Kansas Department of Agriculture
 Division of Water Resources
CHANGE WORKSHEET: PD

RE: Water Right, File No. 2071

RE: Application for Change in Point of Diversion
Water Right, File Nos. 2071

Evaluation of proposed move for Water Right No. 2071

WELL TEST ANALYSIS

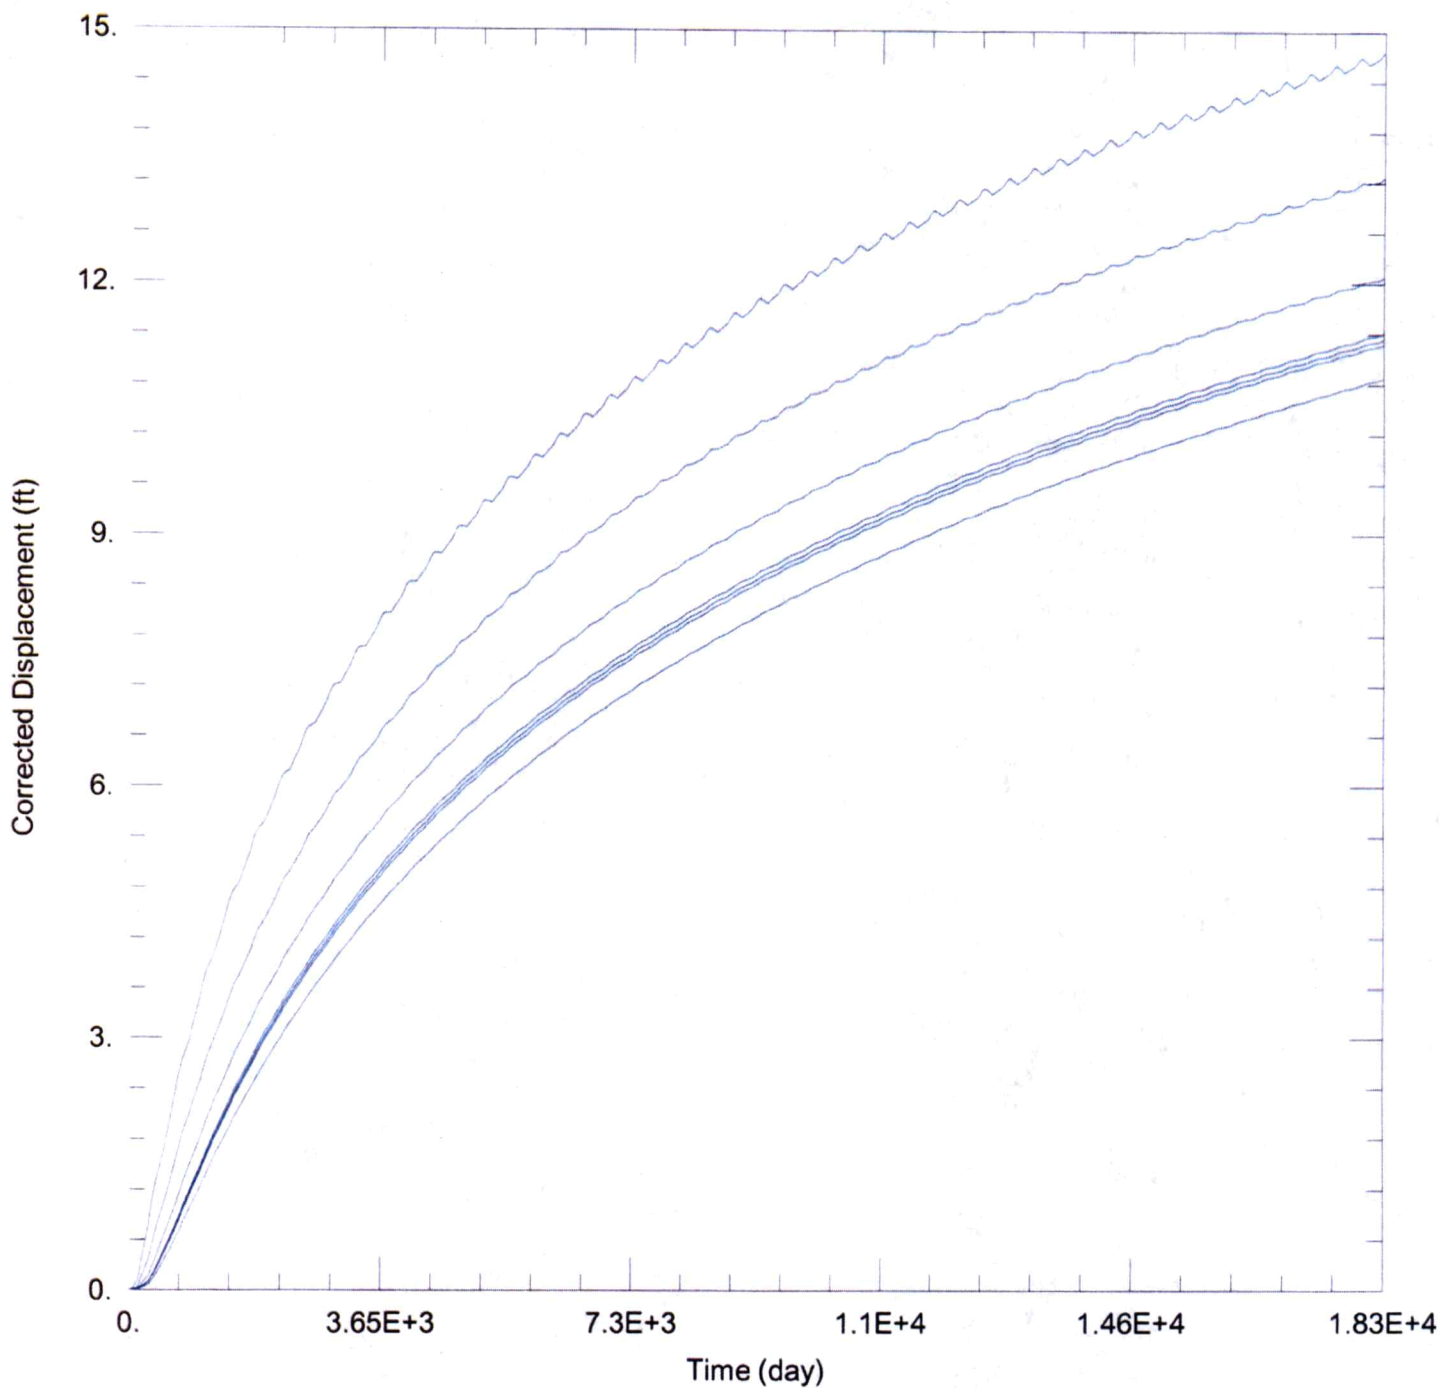
50 year Theis Analysis: The following values were used to run the analysis:

$S = 0.1473$, $T = 1,070 \text{ ft}^2/\text{day}$, $t_{p\text{current}} = 0 \text{ days}$, $Q_{\text{current}} = 0 \text{ gpm}$, $t_{p\text{proposed}} = 294 \text{ days}$, $Q_{\text{proposed}} = 385 \text{ gpm}$

- 9527 & 26724: Net drawdown = **10.9 ft**
- 7389: Net drawdown = **14.8 ft**
- 22950: Net drawdown = **11.3 ft**
- 22910: Net drawdown = **13.3 ft**
- 38606: Net drawdown = **12.1 ft**

Net drawdown exceeds the drawdown allowance for all wells within 1 mile of the proposed location. Critical well analysis is necessary on those wells.
